**Joint Regional Planning Panel
(Sydney East Region) (Supplementary Report)**

JRPP No.	2015SYE164
DA No.:	Demolition of all existing structures, construction of shop top housing development comprising 8 storeys to Green Street, 7 storeys to Maroubra Road with 2 retail tenancies fronting Maroubra Road and 1 fronting Green Street, 69 residential dwellings, 3 levels of basement car parking for 100 vehicles, landscaping and associated works. Amended Plans: Increase setback from the northern and southern edges of the building at Level 6, increase setback from the western boundary, delete units 0.01 to 0.05 to the northern building block, reconfiguration of apartment layout and installation of new privacy louvres.
Street Address	180-188 Maroubra Road, Maroubra
Applicant	Darren John Beasley
Owner	Prime & Famous Pty. Ltd.
Number of Submissions	6
Report By	Matthew Choi

Figure 1: Indicative eastern elevation plan formed part of the proposed amendments as required by the JRPP

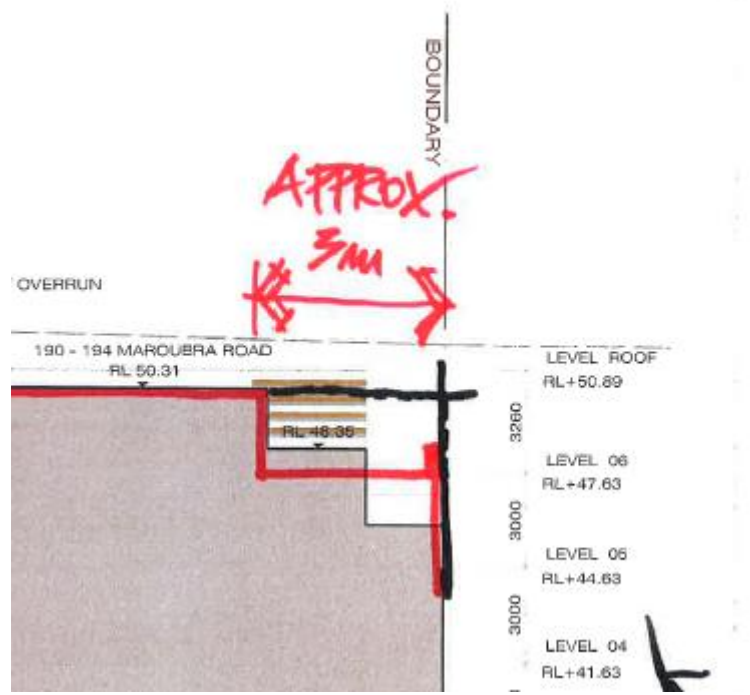
The originally submitted plans show the balconies at Levels 06 of the northern building block (fronting Green Street) setback nil from the northern boundary which will contribute to additional visual bulk and scale of the development when viewed from Green Street. The applicant submitted indicative plans at the conclusion of the Joint Regional Planning Panel and agreed to include a 3 metre setback of the building at Level 06. However, it is unclear from the indicative plans as to whether the JRPP is seeking a 3 metre setback be provided from the external wall of the building or from the balcony. The effect of the amended glass line of the upper level is an increase to the front setback of only 700mm from that originally proposed. The additional setback from Green Street is necessary in order to minimise the apparent bulk and scale of the development by stepping the built form at the top most level in order to alleviate the visual mass of the building. It is noted that a development that complied with the maximum storey control would also provide a transition in height from the B2 zone to the R3 zone on the northern side of Green St. Furthermore, a 3 metre setback from the balcony to the northern boundary will provide a similar balcony and building alignment to the eastern neighbour (190-194 Maroubra Road) and will match the building configuration at the upper most level.

Figure 3: Level 01 Plan of the south unit 1.01 of the southern building block

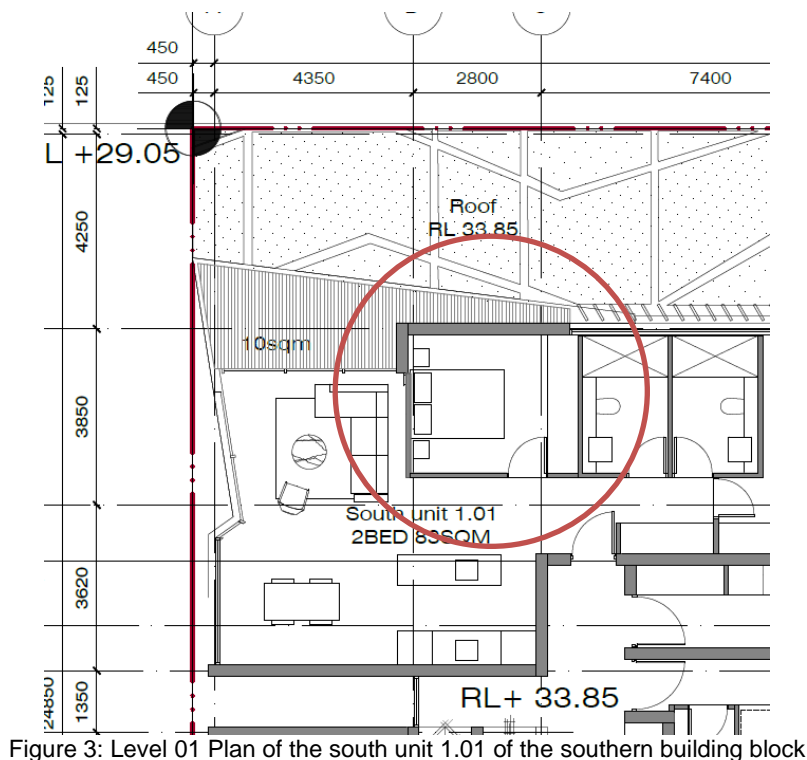
No habitable room window south unit 1.01

The southern-most bedroom to the south unit 1.01 does not include a window opening and therefore does not provide any direct solar access, natural light or ventilation into the habitable room. The ADG requires that every habitable room must have a window in an external wall with a total minimum glass area of not less than 10% of the floor area of the room and daylight and air may not be borrowed from other rooms. The amended plans do not comply with the ADG requirements. Given the corner positioning of these apartments it is possible that a window can be accommodated into the bedroom and appropriate privacy measures can be included to minimise any overlooking.

Figure 4: Window opening to common core area of the southern building block (shown at Levels 01 to 06)

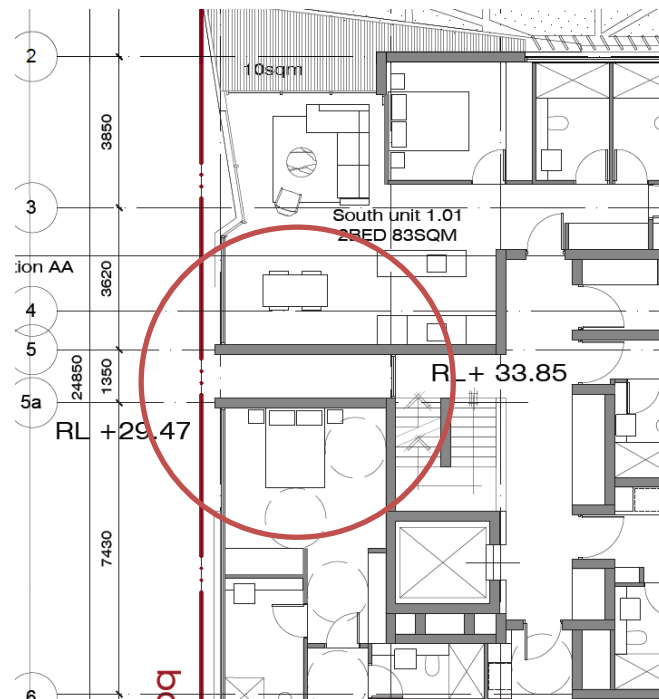
The originally submitted plans failed to provide any window openings to the common circulation spaces to either the northern, southern and western building blocks. The amended plans submitted by the applicant include a new window opening to the new void area created from the western building block and new south facing windows to the common core areas of the building. However, the window opening to the common core areas is significantly recessed behind the external walls between 3.4 to 4.4 metres and will restrict the amount of light penetration into the common core areas. The proposal is still

unacceptable in complying with the ADG requirements in that the common circulation spaces does not achieve a reasonable level of amenity in providing natural ventilation or daylight to the common circulation spaces.

Figure 5: No window opening to bathroom on the southern building block between units 2.01 - 6.01 (shown at Levels 02 to 06)

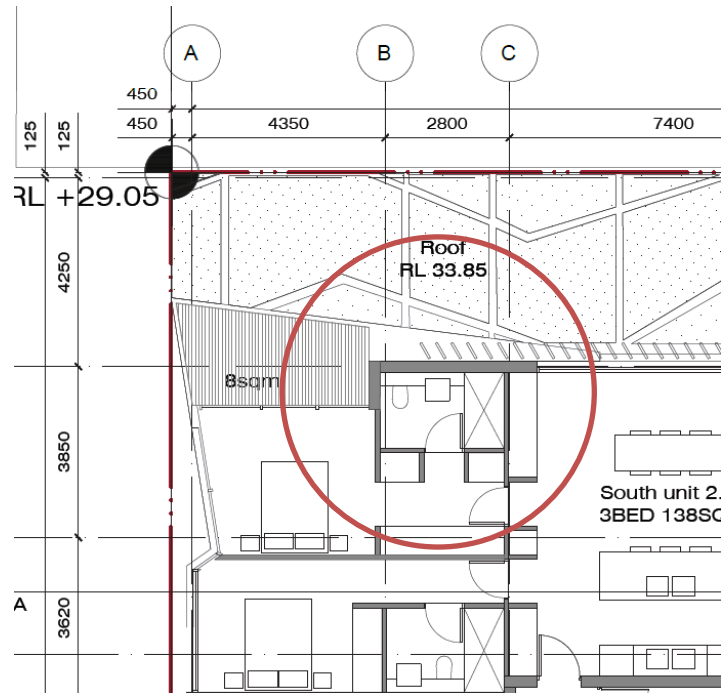
No window openings to bathrooms

The proposed apartment configuration fails to provide a number of windows to bathrooms, in particular those located on the western extremity of the building. The bathrooms adjacent to the western external wall of south unit nos. 2.01 – 6.01 do not provide any window openings and does not comply with the design guidance of the ADG which requires that bathrooms and laundries should have an external openable window where possible. Given the corner positioning of these apartments it is possible that a window can be accommodated into each of the bathrooms and appropriate privacy measures can be included to minimise any overlooking impacts to these spaces.

Figure 6: Reduced window size to bedroom (shown between Levels 01 to 05)

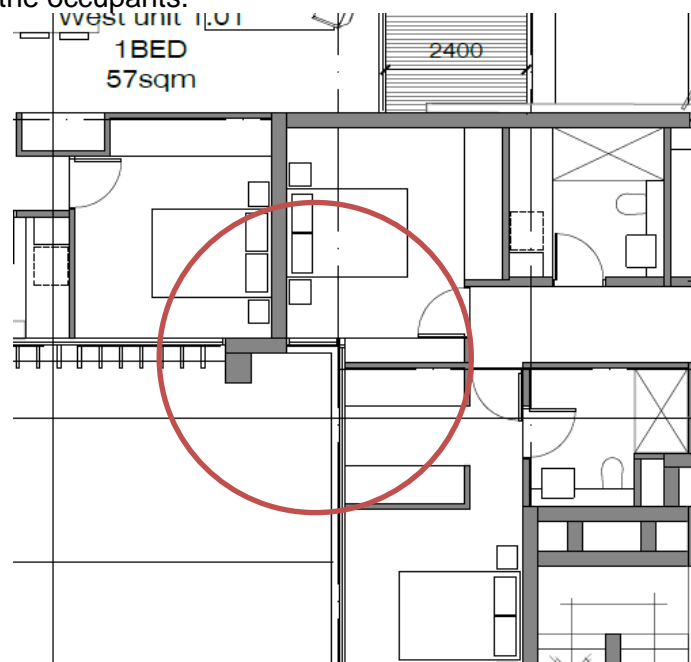
Reduced bedroom window size to north unit 1.01, 2.01, 3.01, 4.01 and 5.01

The modification to the apartment layout involves reducing the size of the east facing window opening to the southern-most bedroom of the northern building block to a maximum width of 600mm. The nominal window opening to the north unit 1.01, 2.01, 3.01, 4.01 and 5.01 does not provide a reasonable level of amenity to the occupants within the building in receiving adequate natural light and ventilation into the habitable room. Further, it is likely that the room will require extensive artificial lighting and ventilation in order to provide internal comfort to the occupants.

Figure 7: Kitchen areas located in main circulation spaces (shown between Levels 01 to 05)

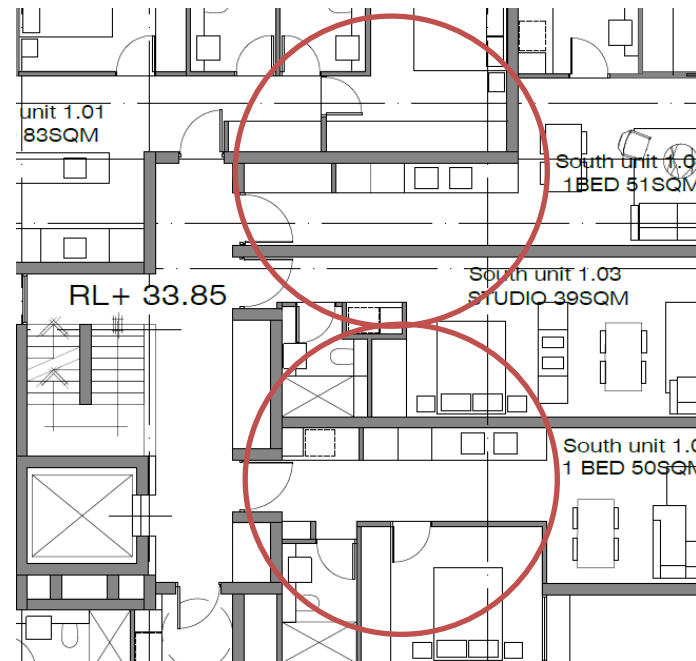
Kitchens located within main circulation spaces

The design guidance within the ADG requirements specifies that kitchens not be located as part of the main circulation space such as in hallways or entry spaces. The apartment reconfiguration does not demonstrate consistency with this requirement given the kitchen areas are co-located within the main entrance spaces and does not create a functional or practical apartment layout for everyday use by the occupants. More specifically, the north units 1.02 – 5.02 and the south unit 1.02 to 5.02 (all between Levels 01 to 05) does not provide a sense of space within the apartments or provide for a well-proportioned apartment layout in particular within high use areas such as kitchens.
